**DELEGATED AUTHORITY REPORT FOR CODE ASSESSMENT DEVELOPMENT APPLICATION
FOR MATERIAL CHANGE OF USE FOR A MULTIPLE DWELLING (100 UNITS) AT 7 & 9 SURF
PARADE, BROADBEACH**

MCU/2025/115

The purpose of this report is to assess an application for a Material change of use (Code assessment) for a Multiple dwelling and Short-term accommodation development at 7 & 9 Surf Parade, Broadbeach.

Figure 19 – Northern side section to existing development (Source: Rothelowman)

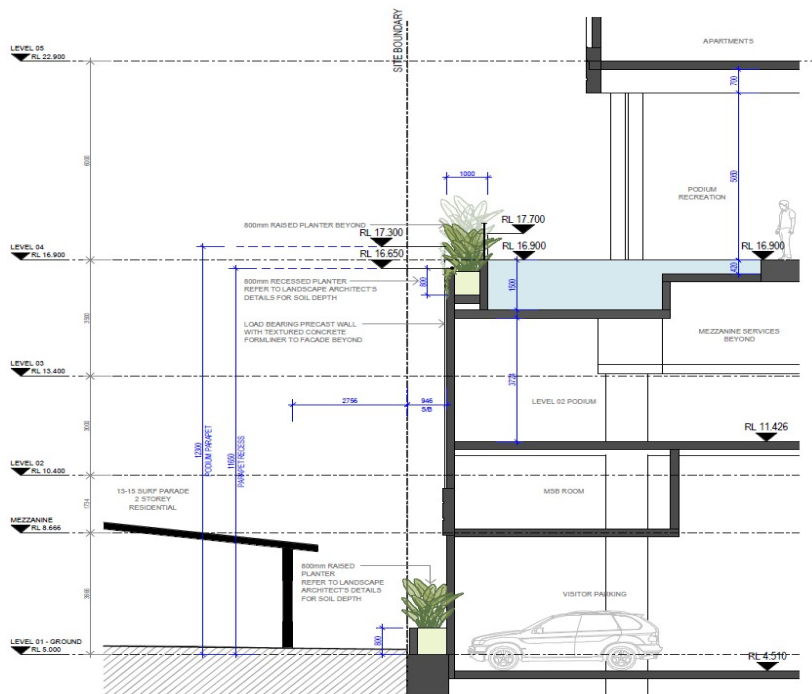
To the northern side, the development proposes Podium setbacks of 0.94m from the Ground floor to Podium Level 4, with the setbacks recessing to 4.4m for Tower Levels 5 and 29. The interface of the Podium to the adjoining two-storey unit block to the north is demonstrated in Figure 19 below.

The above figure demonstrates the separation distance of the proposed development to the adjacent existing building to the north of the site which is approximately 3.7m. The Podium façade design includes open feature screening which presents a woven basket appearance with textured precast concrete panels with elevated landscaping and two podium cut outs to the rear as shown in the figure below.

Figure 22 – Northern side separation distance future development (left) and separation to existing 2 storey development (right) - (Source: Rothelowman & CoGC mapping)

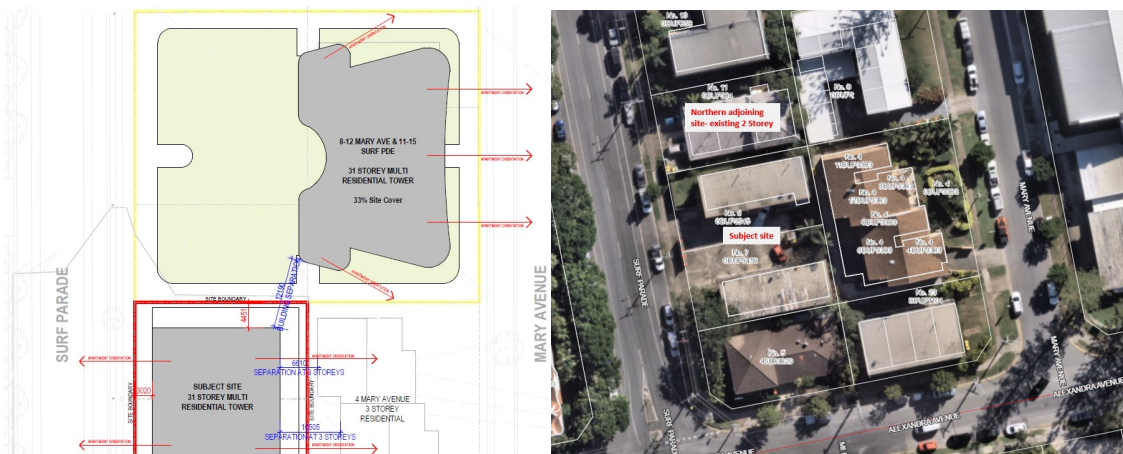
As depicted in the figures above the applicant has provided the Tower separation distance to the potential future development to the site located to the north which is anticipated to comprise a single 31 storey residential tower with 33% site cover. This separation distance from the proposed development to the future potential development is anticipated to be approximately 12.2m.

Figure 23 – Southern side section to existing development (Source: Rothelowman)

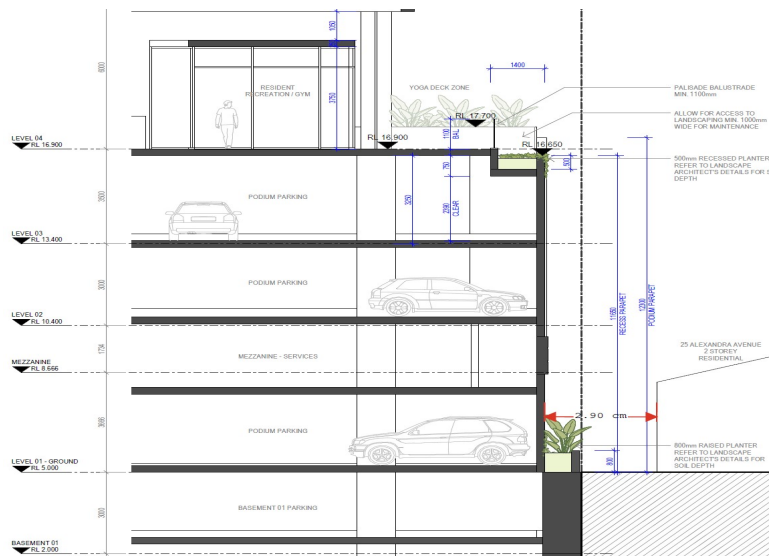
At the southern side the development proposes Podium setbacks of 0.95m from the ground floor to Podium Level 4, recessing to 4.4m for Tower Levels 5 and 29. The interface to the existing adjoining two-storey unit development to the south is demonstrated in the figure below.

The above figure shows a separation distance of approximately 2.9m to the existing building to the south. The applicant has provided the separation distance to the potential future development on the site located to the south which is anticipated to comprise a single 22 storey residential tower with 50% site cover. This future development is anticipated to have a separation distance of approximately 8.455m from the proposed development as shown in the figures below.

Figure 25 – Southern side separation distance future development (left) and separation to existing 2 storey development (right) - (Source: Rothelowman & CoGC mapping)

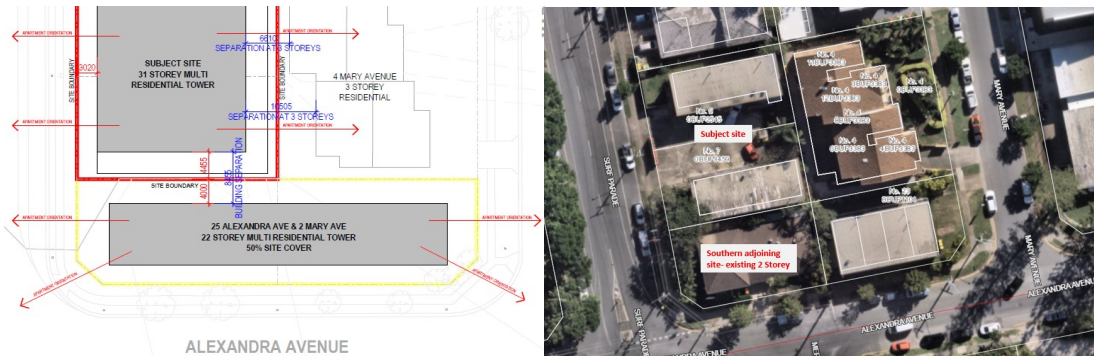
As discussed earlier the interface of the podium and tower of the proposed development with the existing development and future potential development of the adjoining site to the South is appropriate because City officers consider that the separation will adequately protect adjacent amenity.

Figure 26 – Eastern side section to existing development (Source Rothelowman)

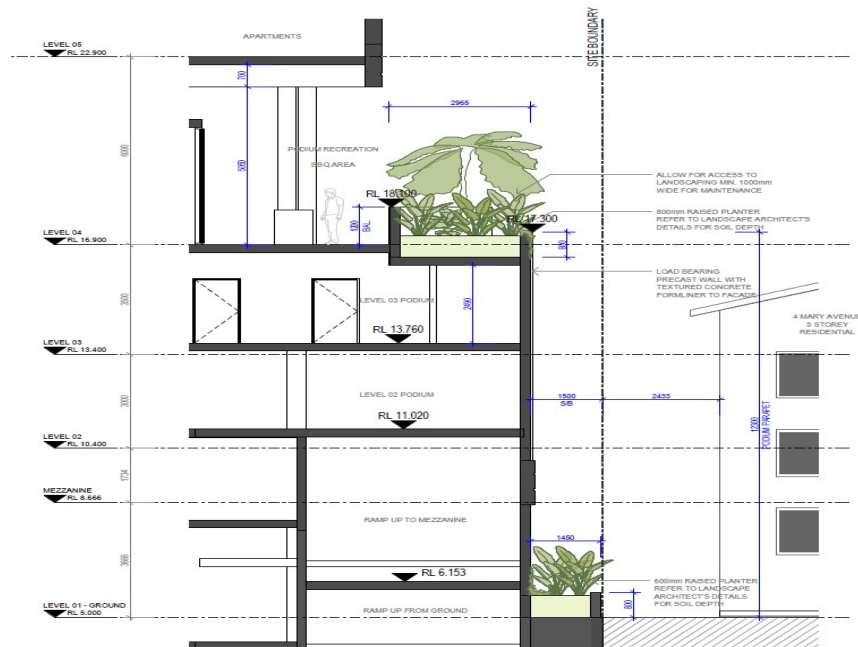
At the eastern side the development proposes Podium setbacks of 1.5m from Ground floor to Podium Level 4, recessing to 4.775m for Tower Levels 5 and 29. The interface to the existing adjoining three -storey development to the east is demonstrated in the figure below.

Figure 28 – Eastern side separation distance to existing 3 storey development (Source: Rothelwman & CoGC mapping)

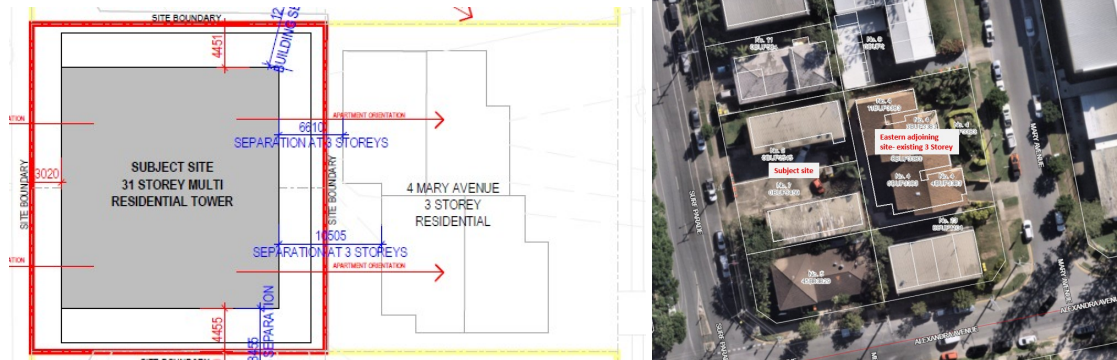
The above figure shows a separation distance of approximately 6.6m to the existing development to the east. The Podium Recreation (Level 4) provides outdoor workout and BBQ areas. The eastern façade includes planters at podium level in the corners and generous planter beds on Level 4. The adjoining development is a three storey building which is orientated to the east refer to Streetview image below.

Figure 31: Frontage streetscape section (Source: Urbis Landscape Concept Report)

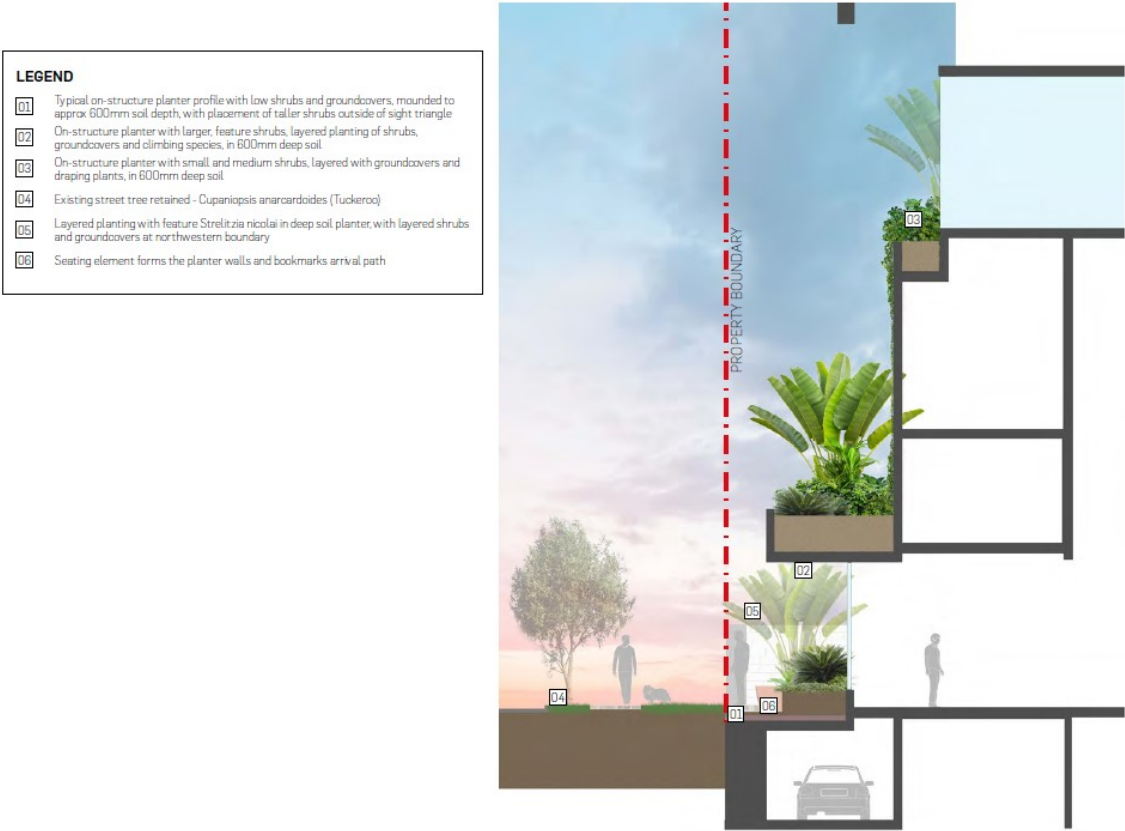
Levels 2 and 3 comprises planters that will include ground covers, layered shrubs, climbing and draping plants to climb and cascade the building façade that will provide a softened layered landscape outcome. Similarly, integrated planting at the ground level and the tower will contribute to a well landscaped design as shown in the below figure.

Equinox - Sun Shading

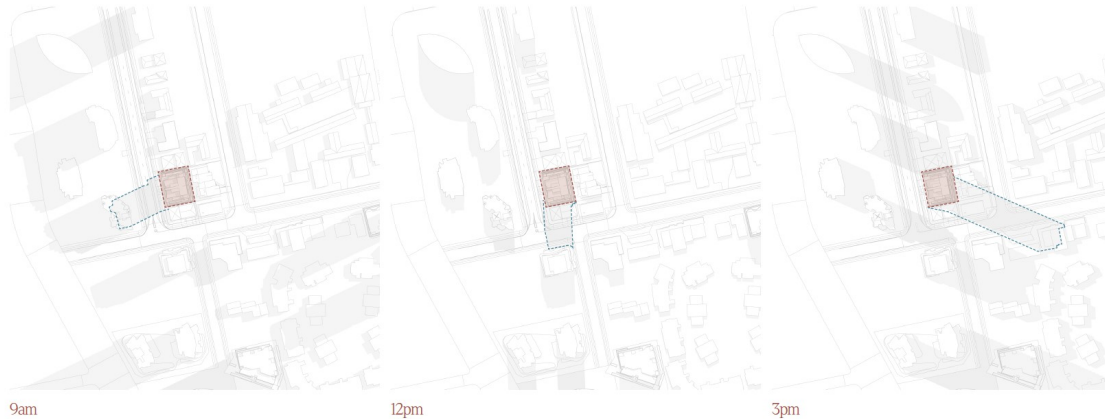
During the spring equinox, at 9:00am the shadow is cast in a western direction over the property to the west.
